RESPONSE TO FURTHER ISSUES LETTER

PDA DEVELOPMENT PERMIT FOR MATERIAL CHANGE OF USE FOR MULTIPLE DWELLING, SHORT-TERM ACCOMMODATION, RETIREMENT FACILITY, SHOP, FOOD AND DRINK OUTLET, HEALTH CARE SERVICE, EDUCATIONAL ESTABLISHMENT, BAR, HOTEL AND INDOOR SPORT AND RECREATION AT 5 HERCULES STREET, HAMILTON

MEDQ REFERENCE: DEV2022/1323

Figure 1 – Approved Ground Floor Plan for 19 Hercules Street, Hamilton (DEV2020/1165)

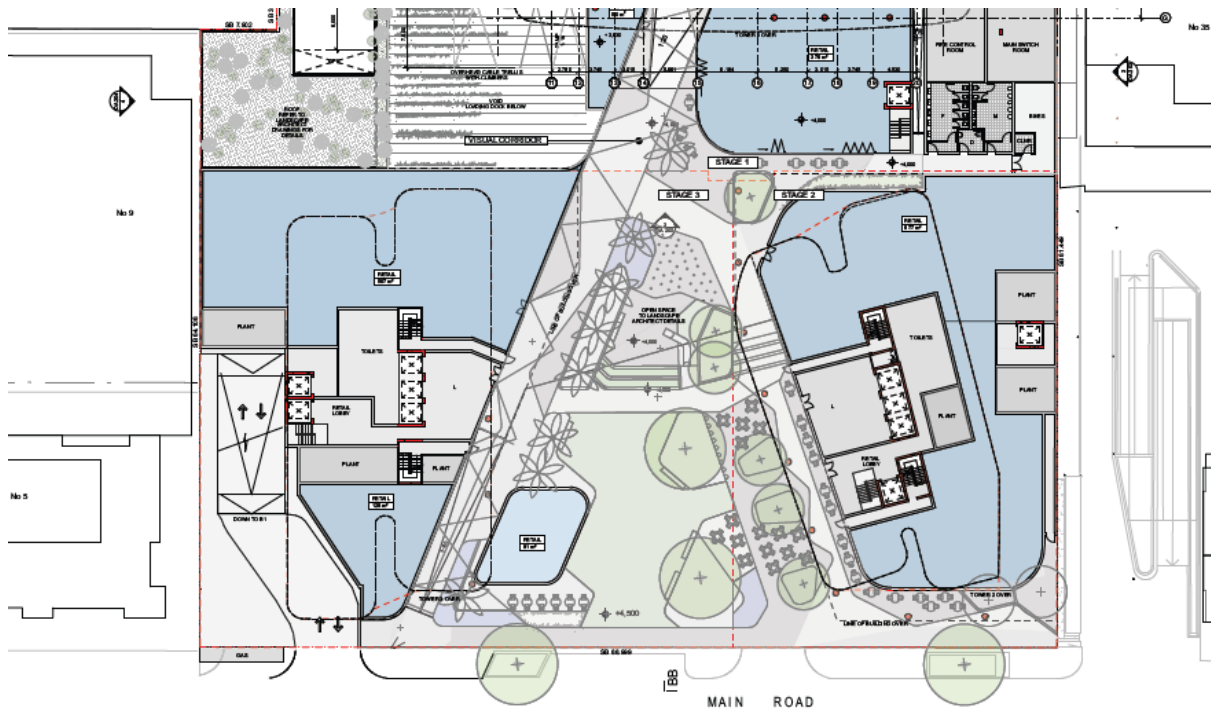
The adjoining property (19 Hercules Street) has an approval for multiple dwelling units with podium and loading areas adjacent to the proposed recreation area on level 4.

Demonstrate how the proposed design responds to the adjoining development and respects privacy of both users.

Whilst it's acknowledged that the adjoining property at 19 Hercules Street is subject to an existing development approval (EDQ Reference: DEV2020/1165), the apartment tower identified closest to the development is noted on the approved plans as 'indicative outline of future stage' and is currently not approved by EDQ and subject to change. However, the approved development does involve the construction of some retail tenancy space and servicing areas (non-habitable spaces) on ground floor level and are built to boundary (as illustrated in **Figure 1** below). Further, there is a mezzanine level containing non-residential uses which is setback 9 metres, and the outline elevations and 3D perspectives show that there is a podium intended for tower 4 (that interfacing the site) which is substantively built to boundary (meeting the proposed development's built to boundary outcome, consistent with the expectations of the Development Scheme).

With the exception of the proposed substation and MSB room (which are built to boundary), the proposed interface with the adjoining development at ground level is to carparking / manoeuvring areas which is to be screened by a 2m wide acoustic barrier and boundary landscaping. Furthermore, neither of the ground floor levels of the two developments are to be utilised for residential purposes and therefore will not result in any amenity to privacy issues. At the podium level, the built to boundary outcome has an appropriate interface to the indicative built to boundary podium represented on the adjoining development's drawings, or to the setback non-habitable mezzanine space. This does not result in any residential amenity impacts on either development.

Figure 4 – Revised arrangements for visitor bike parking spaces on ground level

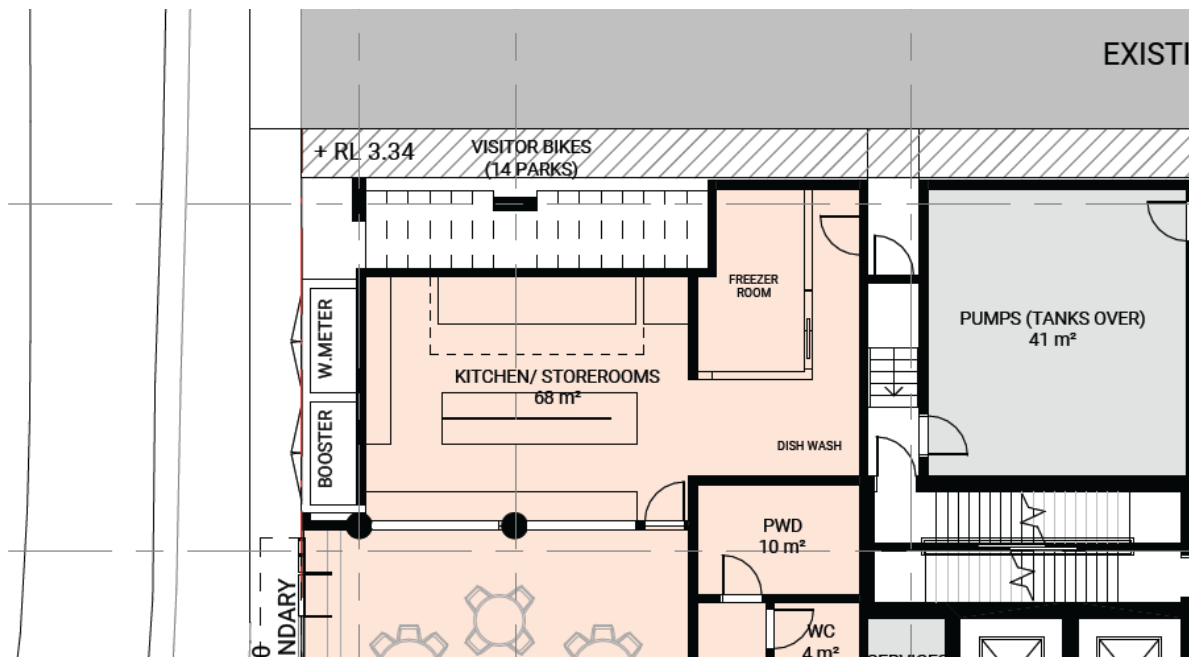
The submitted Architectural Plans show that 14 of the visitor bike parking spaces rely on access via an easement along the northern boundary of the site. From review of the information provided, the easement does not allow access other than the purpose of inspecting, changing, altering, replacing, re-constructing and/or repairing pipes. In addition to this, there are concerns with CPTED with the bicycle access in this location. Submit amended plans relocating the 14 bicycle parking spaces elsewhere within the development or demonstrating an alternative accessway for the bicycle parking.

The water metre and booster have been repositioned along the site's frontage to Hercules and allows for the 14 visitor bike parking spaces to be access without needing to enter the easement along the northern boundary (refer to **Figure 4**). Furthermore, these bike parking spaces are now clearly visible from the street frontage and not considered to be result in a poor CPTED outcome.
